World Forum for Harmonization of Vehicle Regulations**Working Party on Automated/Autonomous and Connected Vehicles*****Fifth session**

UN Regulation No. 79:**Automatically Commanded Steering Function****Proposal for a Supplement to the 03 series of amendments to
UN Regulation No. 79 (Steering equipment)****Submitted by the expert from the European Association for
Electromobility****

The text reproduced below was prepared by the expert from the European Association for Electromobility (AVERE) introducing an amendment to UN Regulation No. 79. It is aimed at clarifying the text of the Regulation. It is based on ECE/TRANS/WP29/GRVA/2019/27. The modifications to the existing text of the Regulation are marked in bold for new and strikethrough for deleted characters.

Graph 1
Indicator time distribution of manually driven 2.275 EU Model 3s, including <2s time

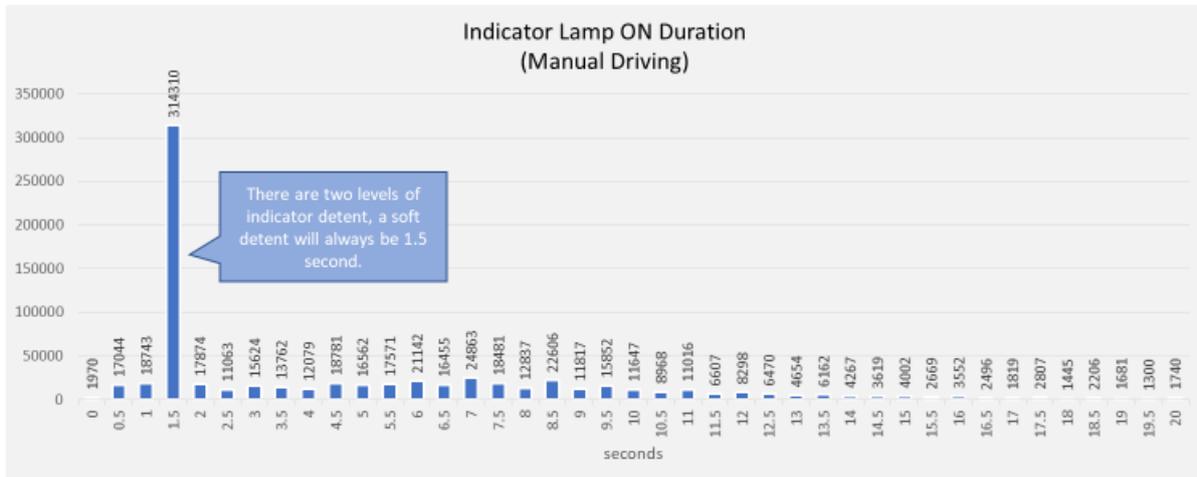
2. Graph 1 below provides a histogram distribution of 2,275 manually driven European Union (EU) Model 3s for 28 days within a 4-month timeframe. The majority of lane-changes are performed with a blinker time leading up to the lane-change manoeuvre of 1.5 seconds, which reflects use of the soft detent on the indicator. (An ACSF of Category C (1-Step Human Machine Interface (HMI)) is currently not allowed to indicate for less than three seconds, again not reflecting natural behaviour). Filtering out indicator times below two seconds provides a clearer spread of indicator use times leading into a lane-change and is representative of driver behaviour in vehicles without such soft-detent functionality. (Graph 3 and 4) The majority of lane-change cases can be captured within 15 seconds of time; longer timed lane changes occur but are more infrequent than shorter lane-change times. This is normal due to the traffic- or infrastructure-conditional, but relatively regular, nature of longer lane change times.

Graph 2
Pie chart distribution of indicator times for a ACSF of Category C1 system not limited by the maximum time requirements (left) and manual driving including soft detent (right), 2275 EU Model 3s

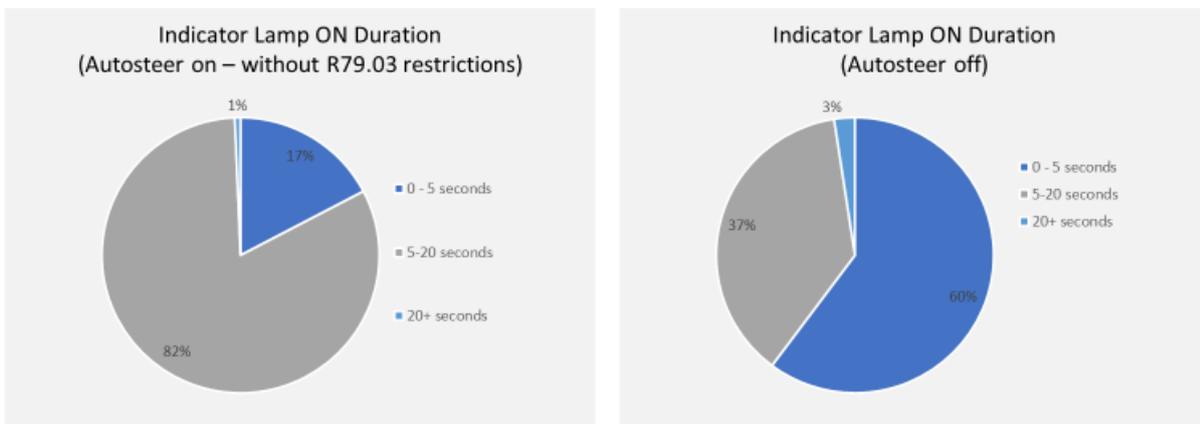
3. An assessment of indicator times of an ACSF of Category C (1-step HMI) system not limited by the UN Regulation No.79 (03 series) requirements shows 5 to 20 seconds are needed in 82 per cent of the lane change cases. (Graph 2). A representation in five second brackets can be found in Graph 4.
